**Re: Lismore City Council – Blakebrook Quarry – Groundwater Assessment Report**

**Attachment A  
Blakebrook Quarry – Post Approval**

**HYDROGEOLOGICAL REVIEW:  
GROUNDWATER MONITORING  
& MANAGEMENT  
BLAKEBROOK QUARRY  
NIMBIN ROAD, LISMORE  
NEW SOUTH WALES**

Figure 3.3.1 Conceptualisation of final excavated void (the ultimate form of this final void is subject to approval by the Secretary)

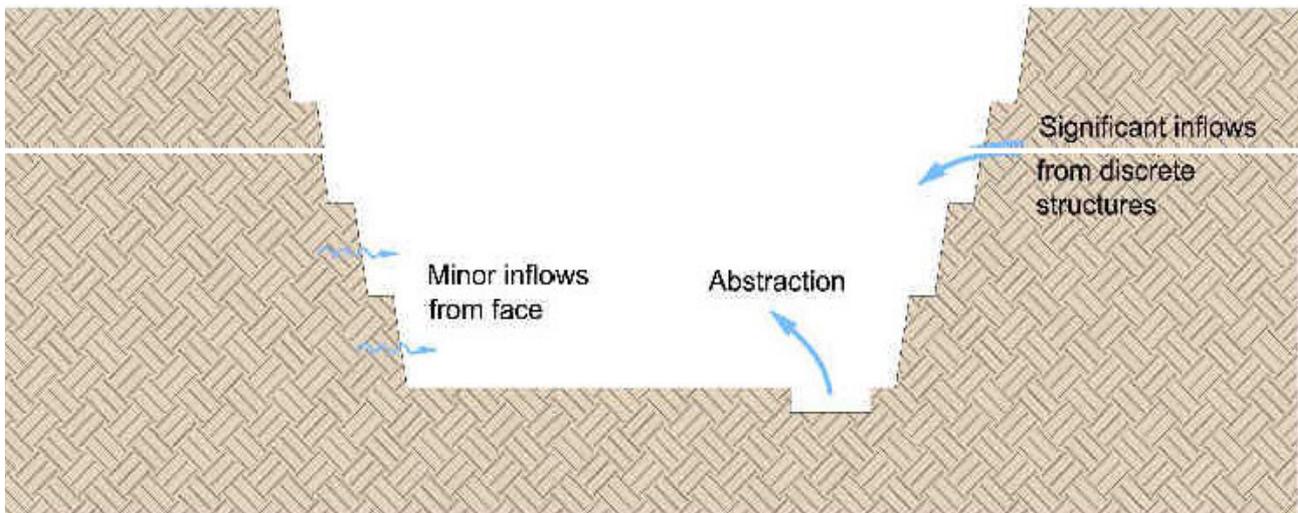
(f) provide data for predicted groundwater pit inflows during and following extraction; and	Partial	See Section 3.3 – The Department requires further justification for the calculated 2.2L/s, noting the information provided in Appendix 6. <b>See Figure 3.3.1 – Please note that this is a concept only and the final void will need to be rehabilitated to the satisfaction of the Secretary.</b>	<b>To note comments and amend the plan accordingly.</b>	Additional text has been added to ensure that it is understood that the final void form and rehabilitation requirements are subject to approval by, and to the satisfaction of the Secretary.

However, to facilitate for the estimate of groundwater inflows, the idealised conceptualisation as shown in Figure 3.3.1 has been adopted.

Given that groundwater inflow to the void will be non-Darcian, the calculated value of 2.2 L/s is likely an overestimate. This being the case, the 2.2 L/s figure is a conservative value at the time of the final quarry void.

SCALE	DATE	DRAWN	CHECKED	PROJECT	DRAWING	REVISION
1:6,250@A3	17/12/2018	AJF	CMA	11737	002	-

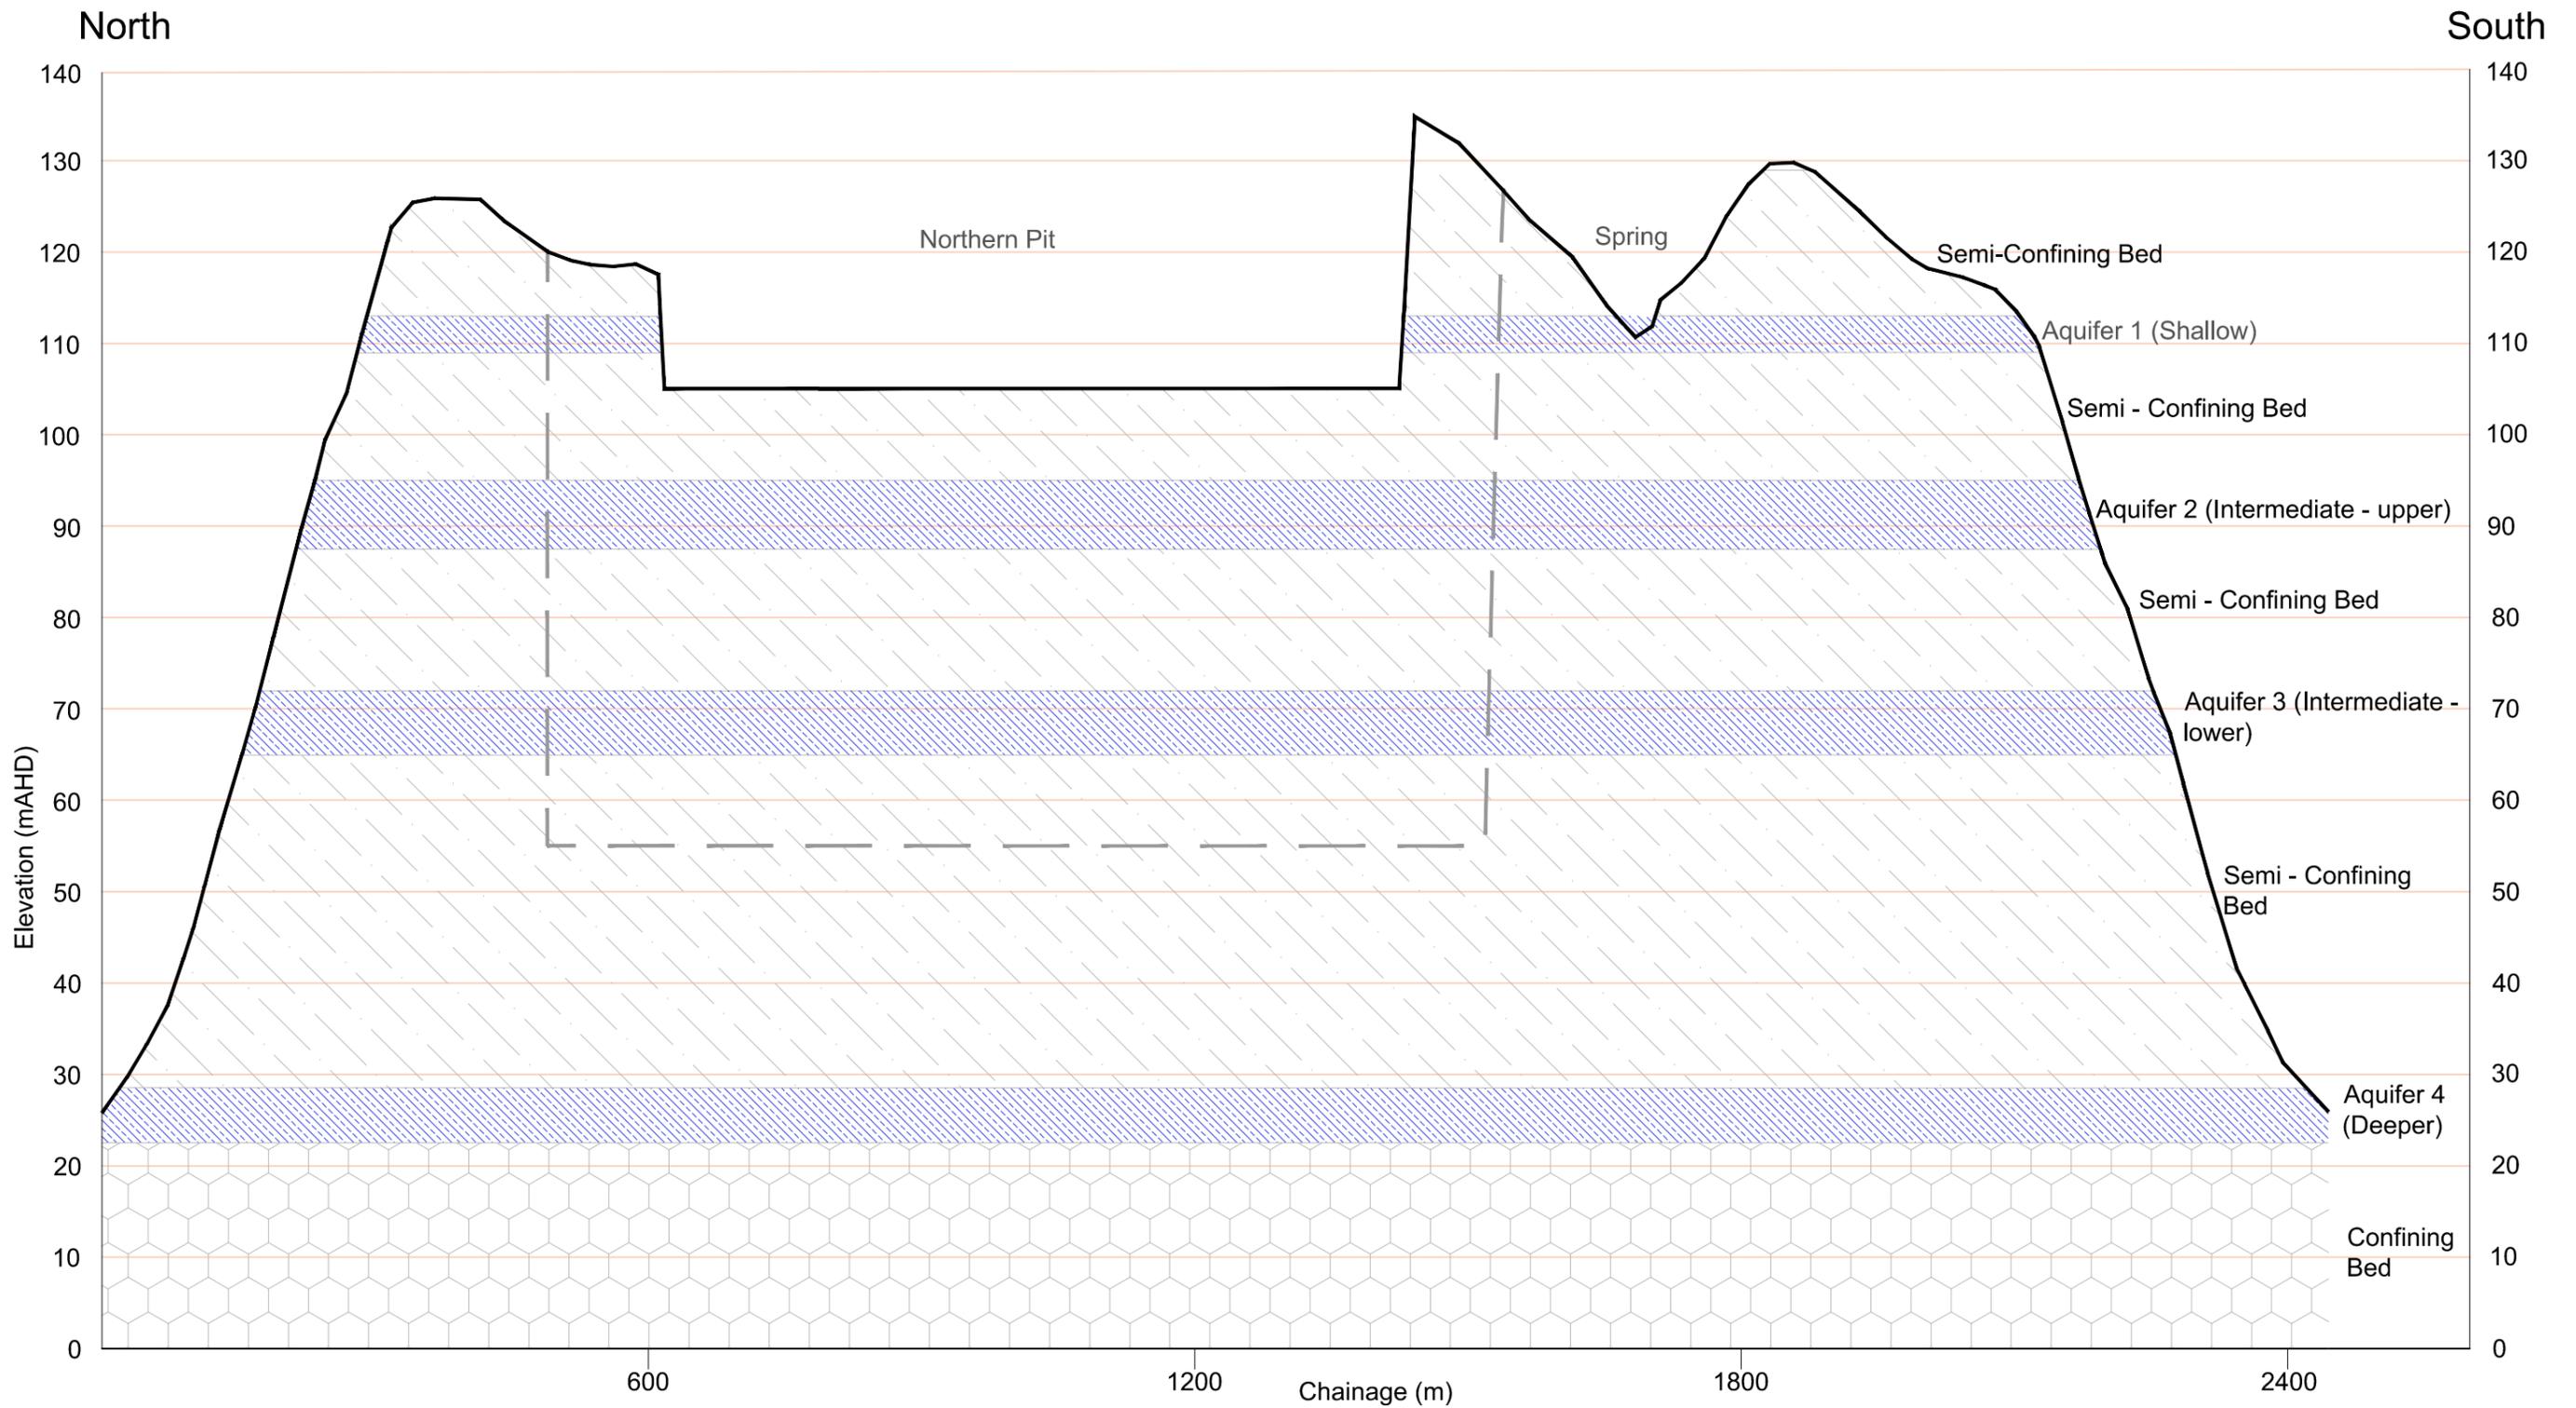
(d) adequately assess groundwater resources affected by the northern and southern pits, to the proposed full extraction depths of those pits;	Yes	See Attachment 1 – Please provide an updated figure clearly indicating the depth of groundwater along each contour. <b>Satisfied – See Appendix 1.</b>	-	--
